Errata: KS8695X Rev. B

Integrated Multi-Port Gateway Solution

Device: **KS8695X**
Revision: **B**
Date: **November 29, 2005**
Errata No.: **ERR8695X-112905**

Figure 1 External I/O 8 bit system Interface

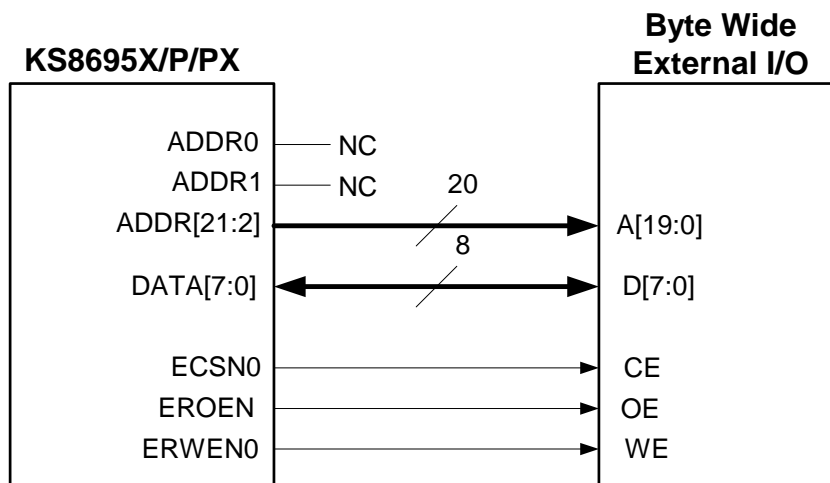
No.	Description	Workaround
1	Packets that have patterns matching the Ethernet IP type field in their payloads at a 32 byte increment may be incorrectly identified as an IP packet. Since the packet will not have a correct IP checksum, it will be dropped. The probability of packet drop is very low.	Turn off hardware IP filtering functions.
2	For packets <49 bytes, IP header checksum is not generated	Use software to pad packets to at least 49 bytes in length.
3	8 or 16-bit External I/O Port Read Access Extra Cycles. The external I/O controller and the static memory controller (NOR Flash and SRAM) share the same data bus and an internal read buffer used by ARM AHB interface for data transfer. The read buffer is 32-bit wide and on every read operation the buffer is filled with 32 bits of data. Therefore for 8 or 16-bit port interfaces there will be multiple read cycles to fill the 32-bit buffer. This is acceptable for static memory since extra cycles are used to cache the data and are harmless. However, extra cycles can possibly have side effects for certain external I/O devices such as inadvertent clearing of a pending interrupt. This particular problem does not exist for 32-bit ports since every access completes in a single cycle.	<p>For the External I/O, every read from an 8-bit port must be presented as a 32-bit interface. The following steps implement this procedure:</p> <ol style="list-style-type: none">1. Program ERGCN (register offset 0x4020) bits [21:16] to 32-bit Data Width.2. S/W shift address by 2 bit position to left: A3A2A1A0=0000 → 0000, =0001 → 0100, =0010 → 1000, etc.3. H/W shift address bus by 2 bit position: A[21:0] → A[21:2]. See Figure 1 for illustration of system interface. <p>Every read from 16-bit port must be presented as 32-bit interface. Following steps implement this procedure:</p> <ol style="list-style-type: none">1. Program ERGCN (register offset 0x4020) bits [21:16] to 32-bit Data Width.2. S/W shift address by 1 bit position to left: A3A2A1A0=0000 → 0000, =0010 → 0100, =0100 → 1000, etc.3. H/W shift address bus by 1 bit position: A[21:1] → A[21:2]. See Figure 2 for illustration of system interface.
